***LEESBURG BOARD OF ARCHITECTURAL REVIEW
STAFF REPORT***

PUBLIC HEARING: JULY 2, 2012
AGENDA ITEM 6.a

THLP-2011-0051 Leesburg Toyota
1-3 Cardinal Park Drive, H-2 Overlay District
Miguel Yelos San Martin, YSM Design, Applicant
Leesburg Motors, LLC. Owner
YSM Design, Architect

Figure 1. Third Design

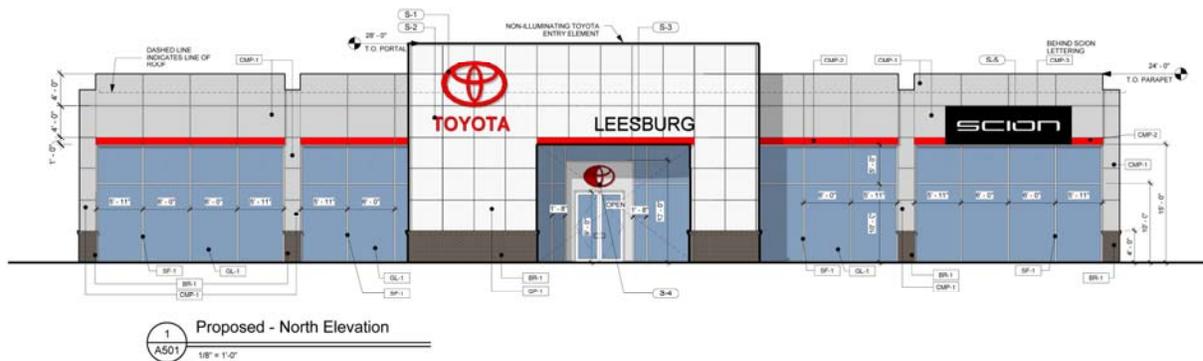
- North Elevation (Main Façade facing Route 7) – See Figure 1 for a comparison to the Third Design:
 - Retains the translucent glass portal but with four feet of dark brick “wainscoting” at the portal base.
 - The metal panel on the columns has been replaced with light grey brick.
 - A brick cornice is proposed along the top of the façade.

- At the storefront base 18” of dark brick has been added along the façade.
- Metal accent panels have been retained above the storefront windows as mentioned above.

- The dark brick foundation wainscoting four feet tall shall be continued on the West and South Elevations.
- The composite metal panels on the North Elevation shall be deleted and replaced with either light grey brick or light grey ceramic tile.
- A significant portion of the face of the portal on the North Elevation shall be composed of white tile similar to that used on the sides of the portal.

Figure 6. East Elevation –Fourth (New) Design

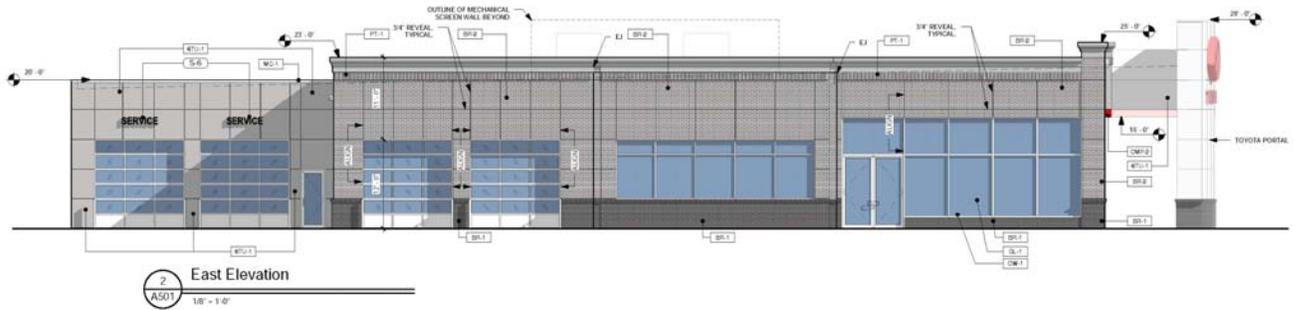
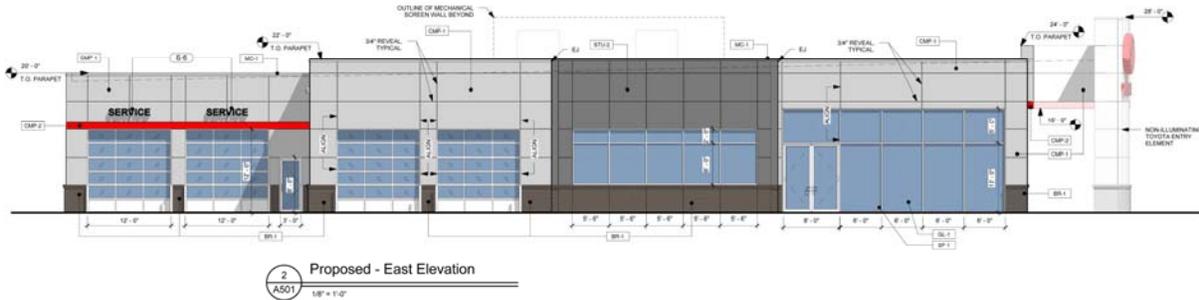
- East Elevation (side facing Cardinal Park Drive)
 - Metal panels have been entirely removed and replaced with light grey brick along ¾ of the façade length.
 - The remaining 1/4 recessed portion of the façade around the service bays is replaced with light grey stucco.
 - At the storefront base 18” of dark brick has been added.

Figure 7. South Elevation – Fourth (New) Design

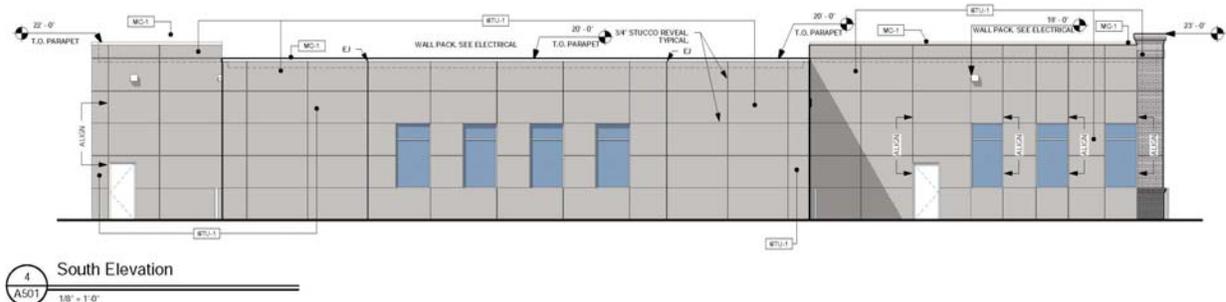
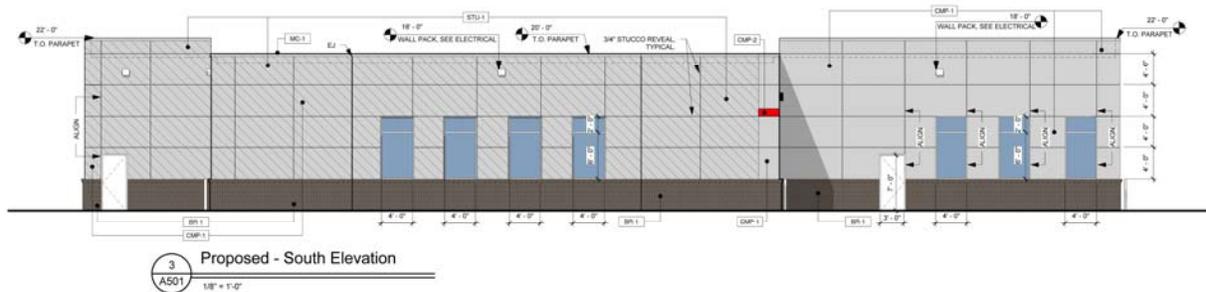
- South Elevation (rear facing Southern Electric)
 - Stucco has replaced composite metal panels along the entire wall except for brick as a transition element at the southeast corner.
 - The four-foot tall dark brick wainscoting has been dropped from this elevation.

The South and West Elevations are now a combination of brick and stucco, with stucco predominating on each façade. However, the four-foot tall brick wainscoting around the foundation has been removed from these elevations where stucco walls are used. Staff recommends that this defined foundation brick area be restored below the stucco walls as shown on the previous (Third) design.

Figure 8. West Elevation – Fourth (New) Design

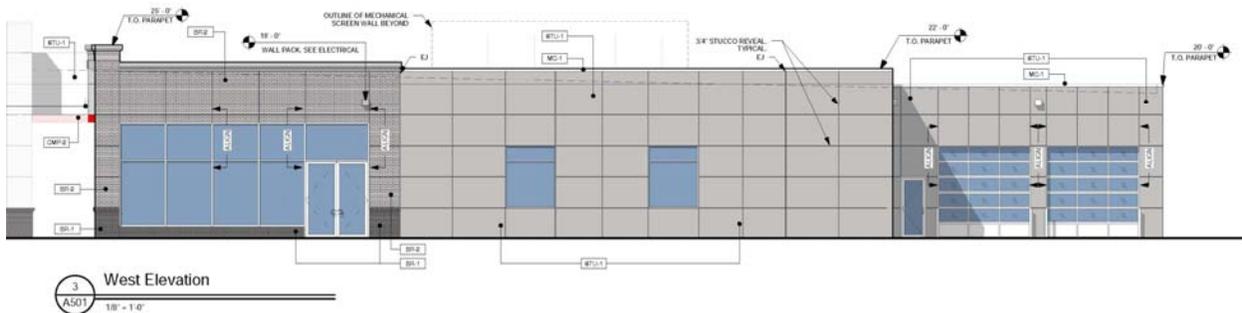
- West Elevation (side facing Jerry's Ford)
 - The storefront portion of this elevation is now characterized by light grey brick instead of stucco.
 - At the storefront base 18" of dark brick has been added.
 - The remainder of the elevation (approximately 3/4) is covered in stucco.
 - The four-foot tall dark brick wainscoting has been dropped from this elevation.
